APPENDIX R

Proposed Project Revisions

MEMORANDUM

Subject: Proposed Project Revisions (JVR Energy Park)

The increased setbacks and water main realignment are described further below and are shown in Figure 1, Project Components.

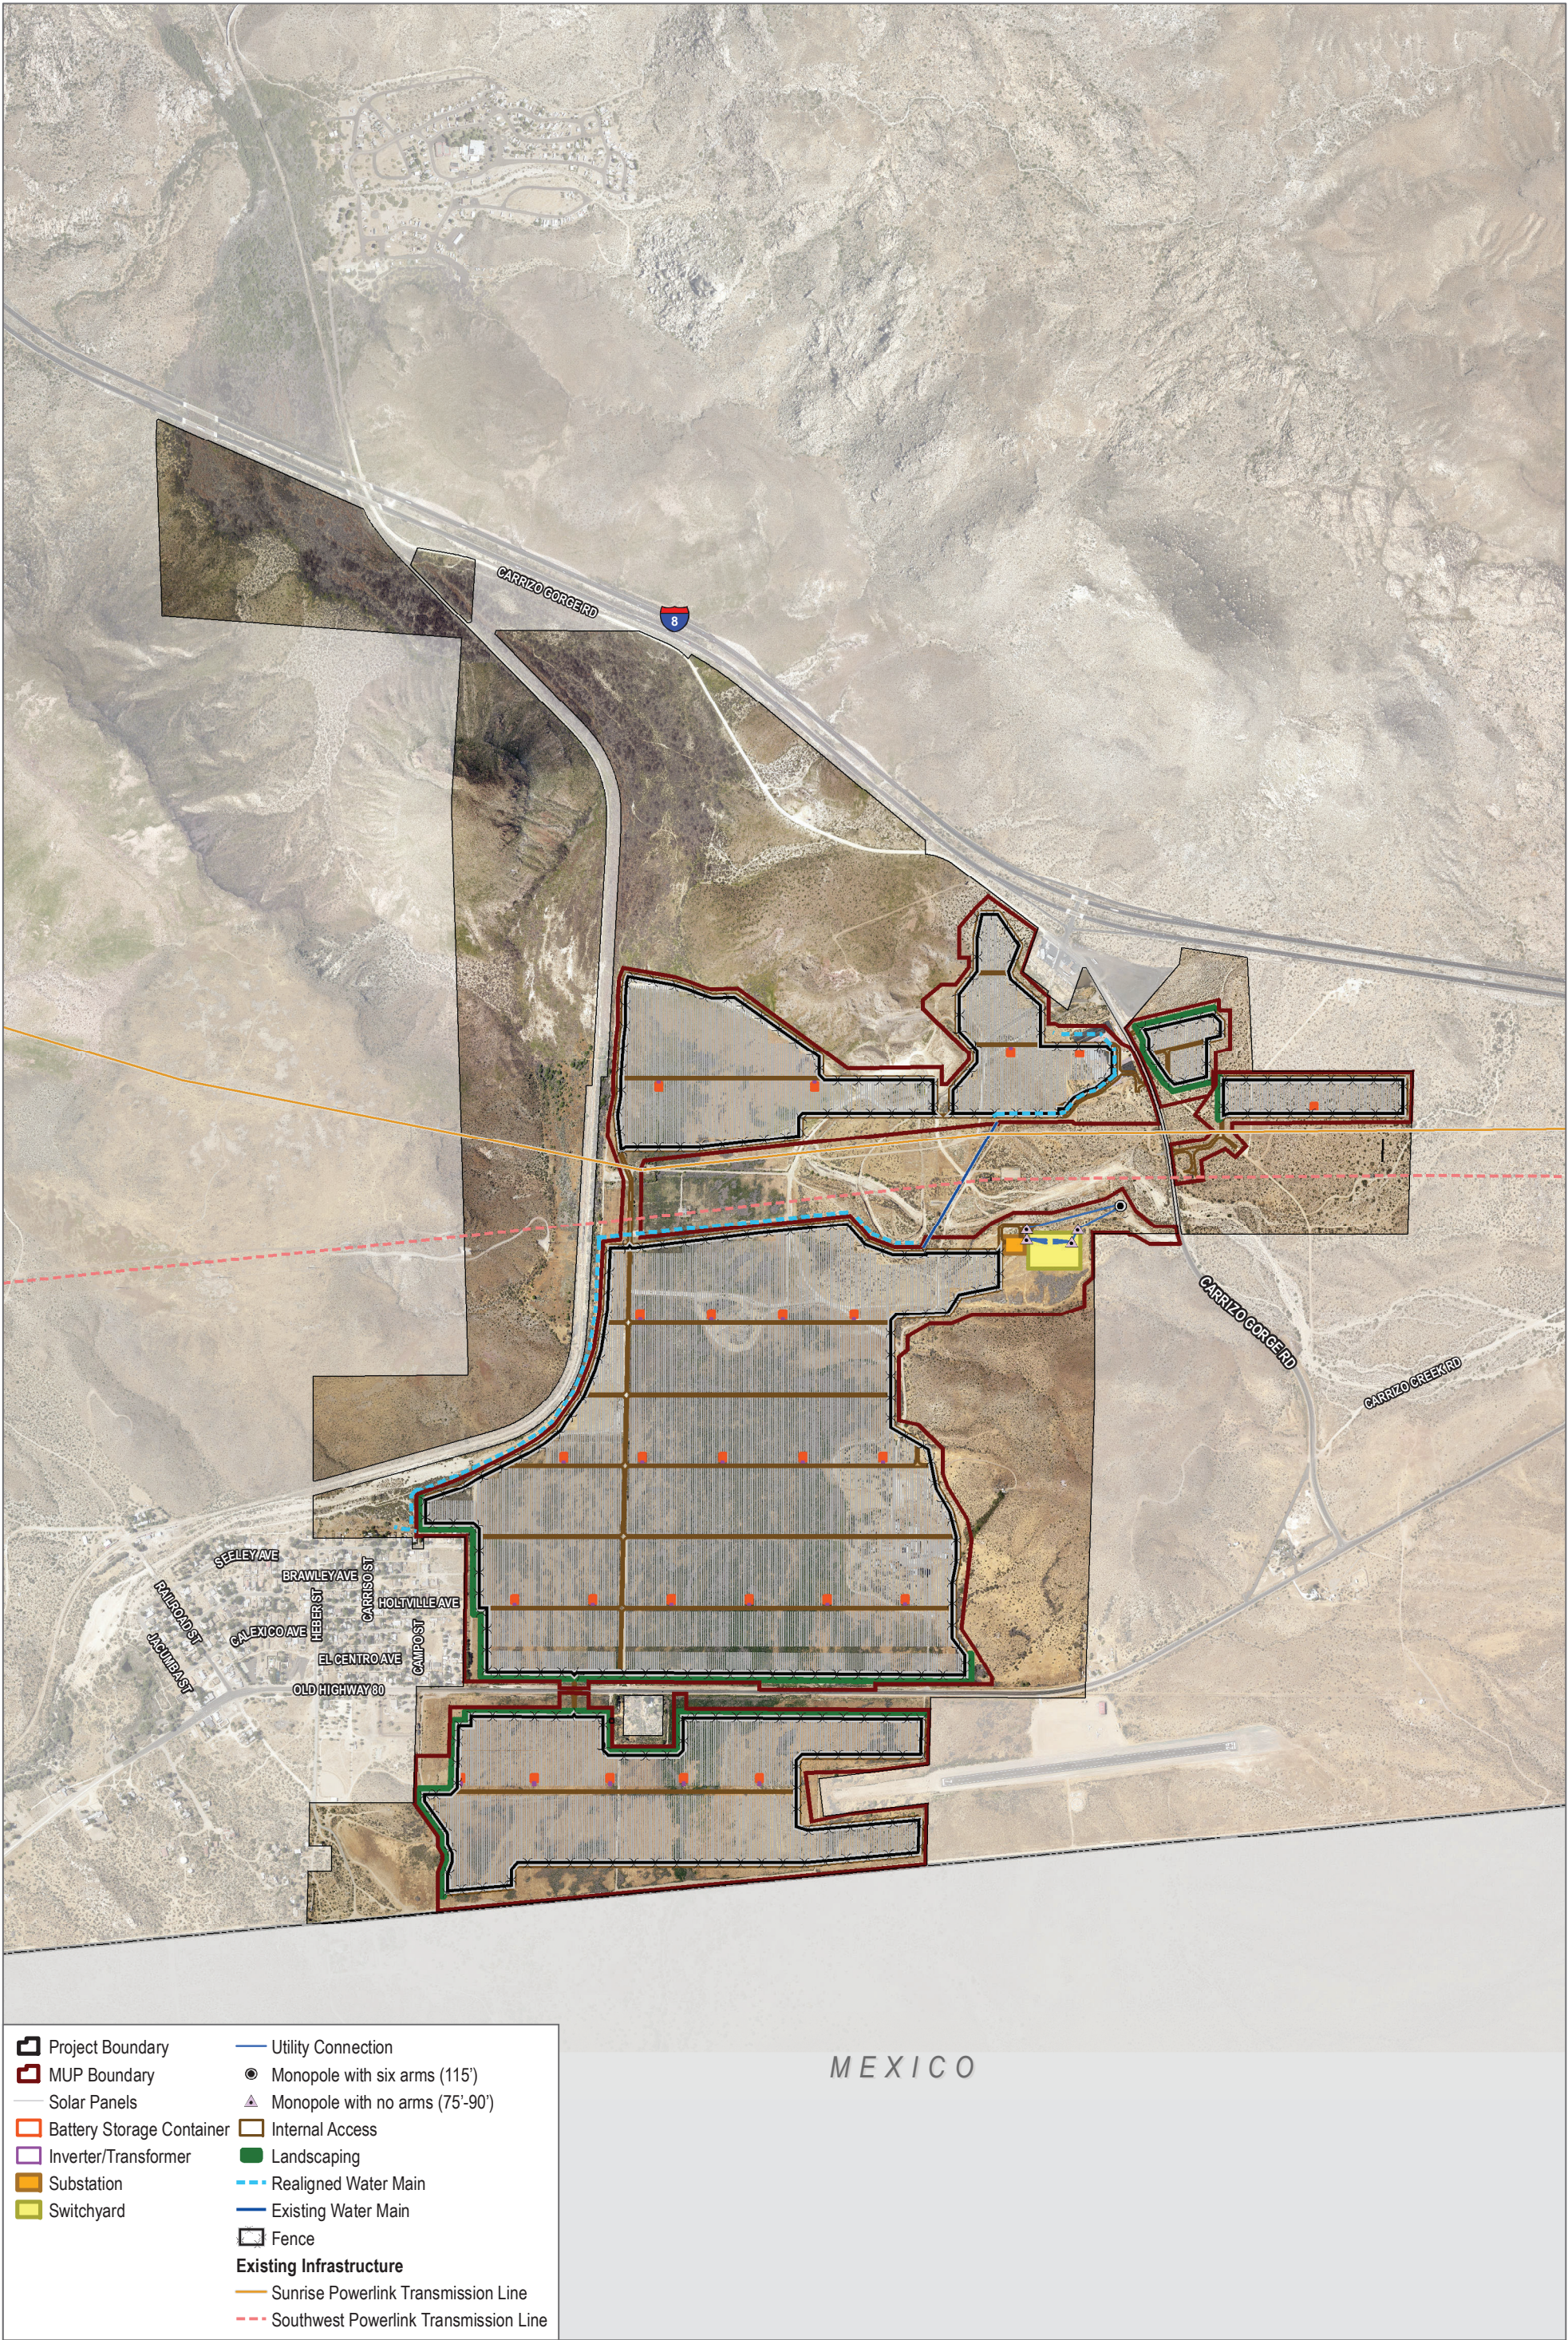
- **Revised Major Use Permit Boundary:** As a result of the increased setbacks described below, the size of the Major Use Permit area has been reduced from 643 acres to 623 acres.
- **Increased Setbacks from Old Highway 80:** Along Old Highway 80, the Proposed Project fence line on both sides of the roadway has been set back further to provide a larger buffer between the roadway and the Proposed Project. The fence line along the north side of Old Highway 80 will be 70 feet from the Project property line to the fence line (110 feet from the edge of the pavement on Old Highway 80 to the fence line), providing a buffer to the north that is 52 feet more than described in the Draft EIR. The fence line along the south side of Old Highway 80 will be 140 feet from the Project property line to the fence line (175

to 180 feet from the edge of pavement on Old Highway 80 to the fence line), providing a buffer to the south that is 122 feet more than described in the Draft EIR.

- **Increased Setback from Jacumba Community Park:** Adjacent to the Jacumba Community Park, the Proposed Project fence line has been set back further to provide a larger buffer between the park and the Proposed Project. The fence line adjacent to the park will be 300 feet from the Project property line to the fence line.

There is an existing approximate 9,000-foot water main that provides potable water to commercial uses on Carrizo Gorge Road, which crosses the Project site. The water main is operated by the Jacumba Valley Ranch Water Company (formerly Ketchum Ranch Water Company) under permit from the County of San Diego Department of Health. The existing water main runs from the Jacumba Valley Ranch Water Company Well located on the west side of the site to a water storage tank on the eastern portion of the site. A separate water main diverges to the north prior to reaching the water storage tanks on the eastern portion of the site and runs to the two gas stations located on Carrizo Gorge Road, adjacent to the Project site near Interstate 8.

After consultation with the Jacumba Valley Ranch Water Company, it has been determined that the existing water main is inconsistent with the Proposed Project design. Accordingly, a portion of the existing water main will be rerouted around the Project site outside of the MUP boundary to connect the Jacumba Valley Ranch Water Company connections north of the Project site. The new alignment would be approximately 9,500 feet long and would partially be routed outside the MUP boundary as shown in Figure 1. (Less than 1 acre of the water main realignment will be outside of the MUP boundary analyzed in the Draft EIR but within areas previously surveyed.) The new alignment would tie in to the southern and northern ends of the existing water main that crosses the SDG&E transmission line easement. No work would occur within the SDG&E transmission line easement. The remainder of the existing water main would be abandoned in place. The new water main alignment would be cleared of vegetation. The water main would be installed using a trencher that would dig an approximate 18-inch-wide trench to a depth of 3.8 feet. After the water main is installed, the trench would be backfilled and seeded. The water main realignment would not increase or modify the use of the well or groundwater production by the Jacumba Valley Ranch Water Company. The well and the water main will continue to be owned and operated by the Jacumba Valley Ranch Water Company.

FIGURE 1
Project Location
JVR Energy Park Project

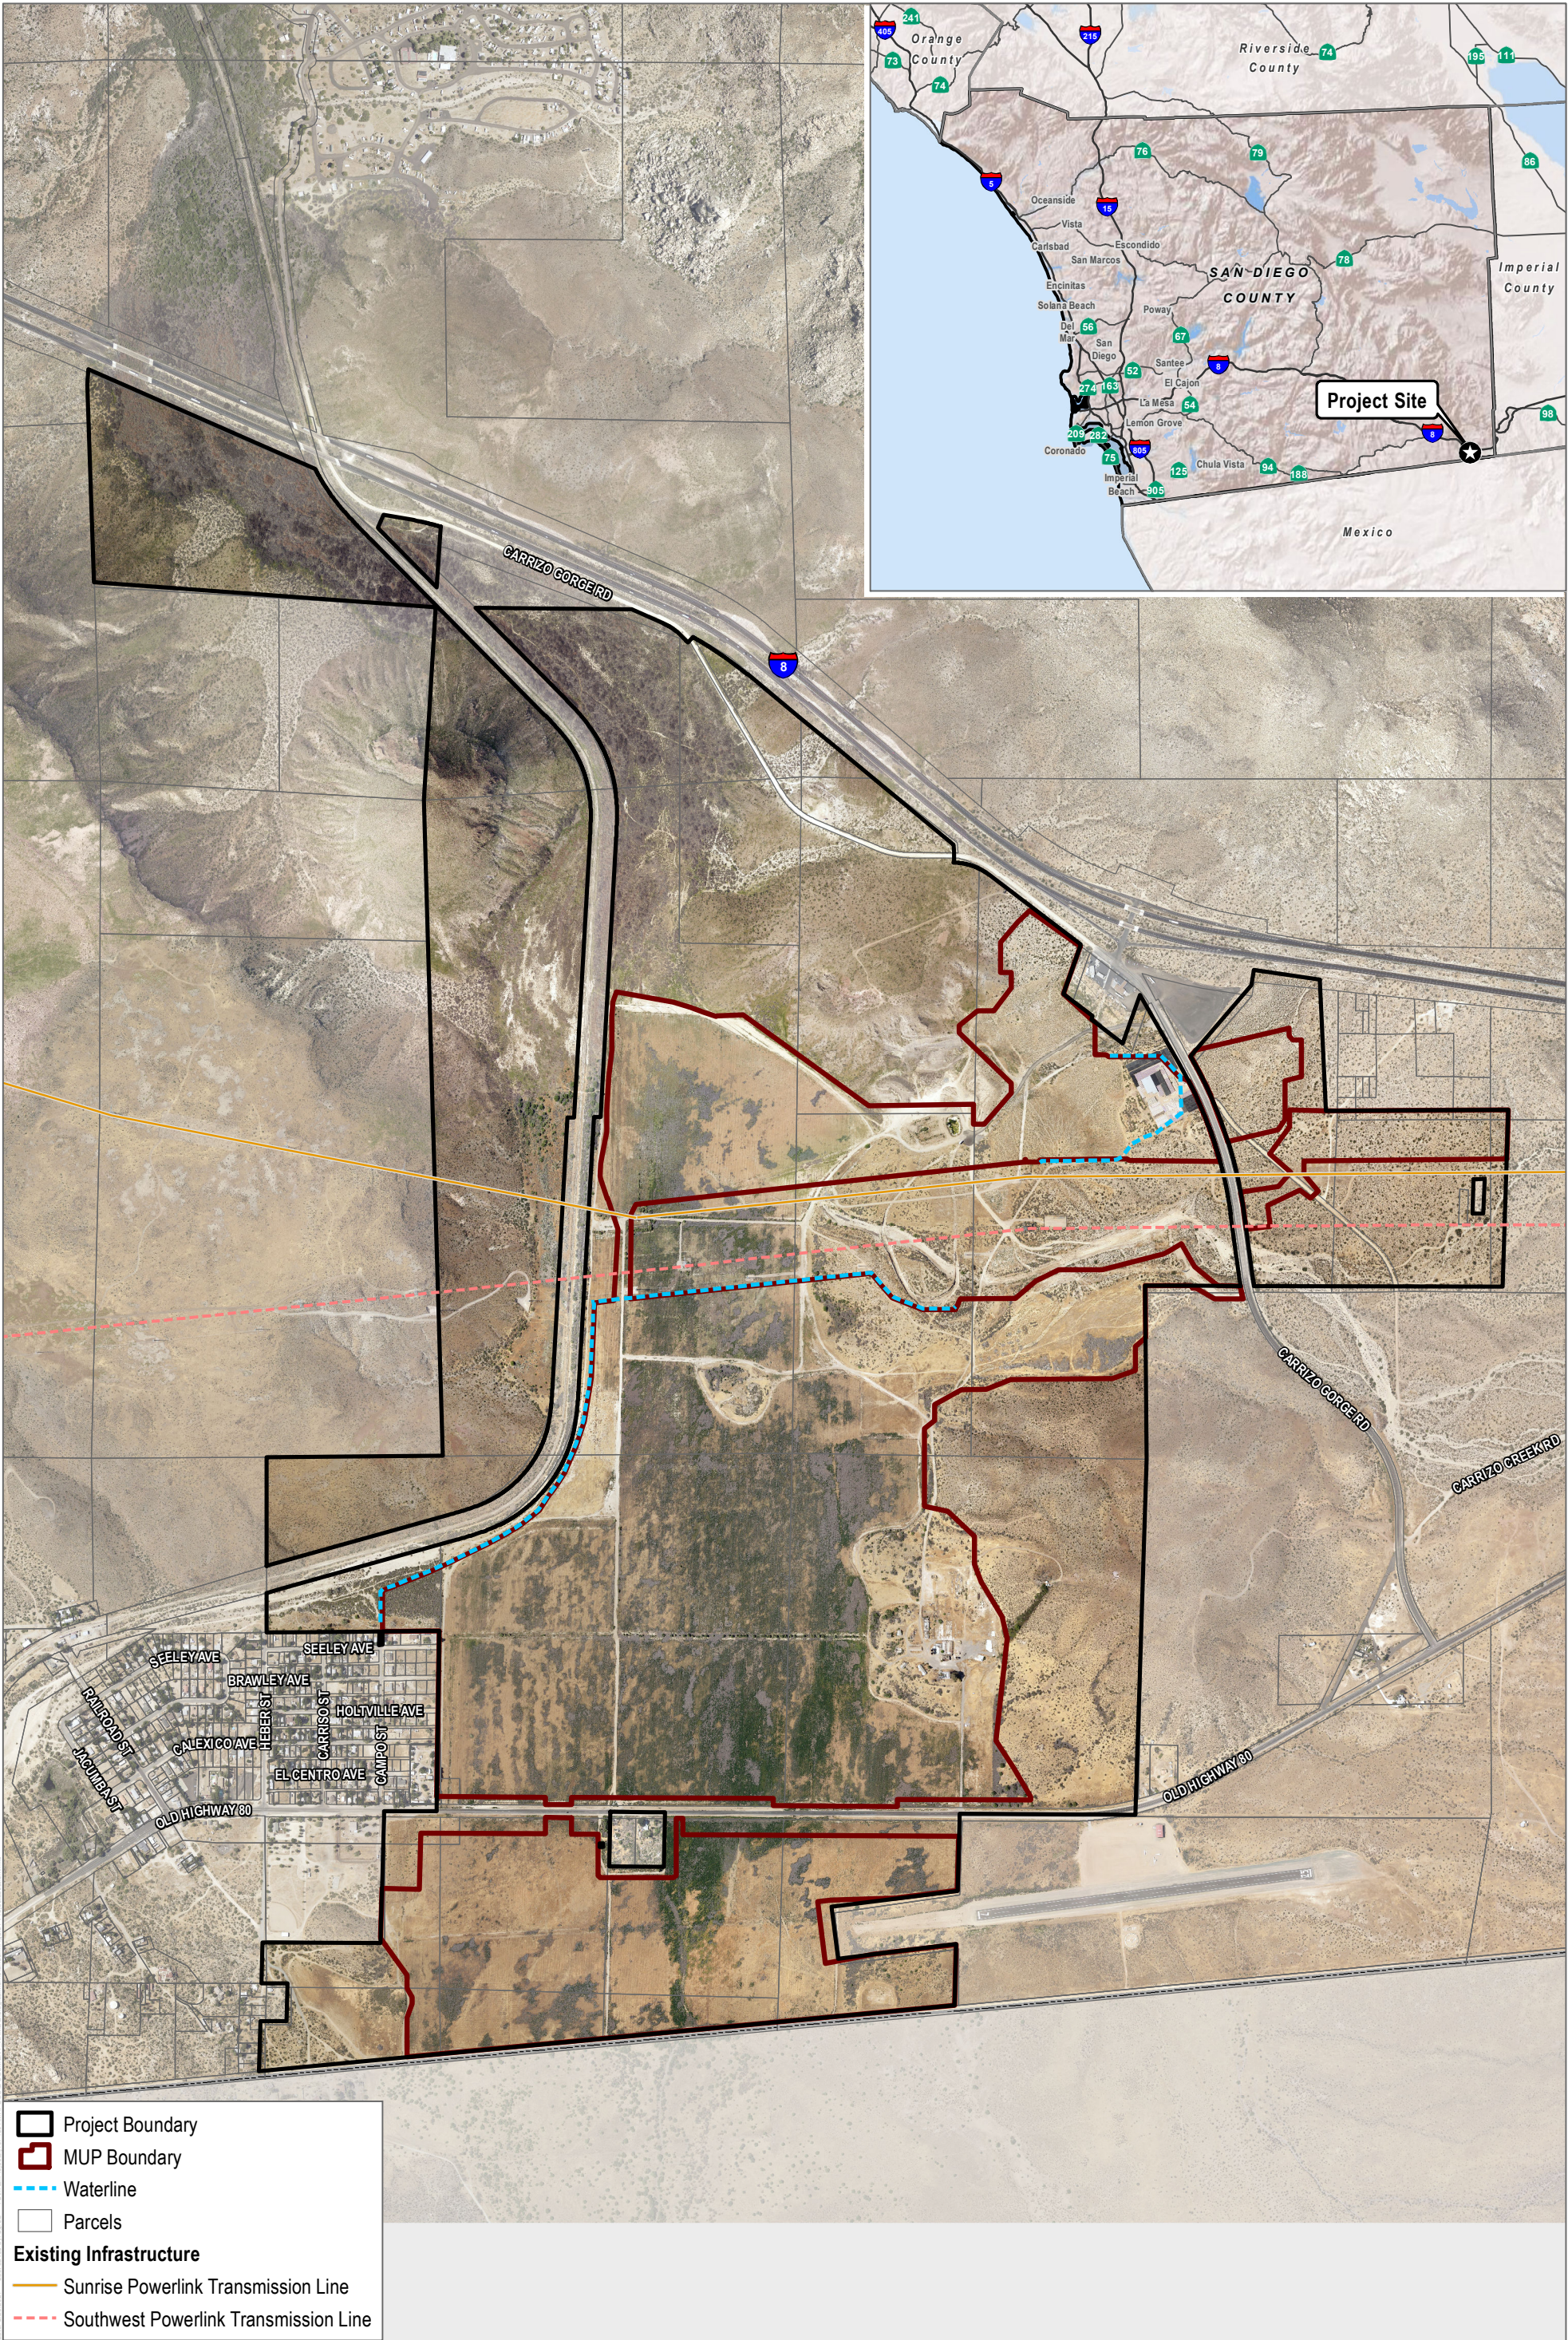
The Proposed Project was revised to include increased setbacks along Old Highway 80 and Jacumba Community Park. The Proposed Project also now includes the realignment of an existing water main. The new water main alignment would be approximately 9,500 feet long and would be routed outside the project MUP boundary as shown on Figure 1.
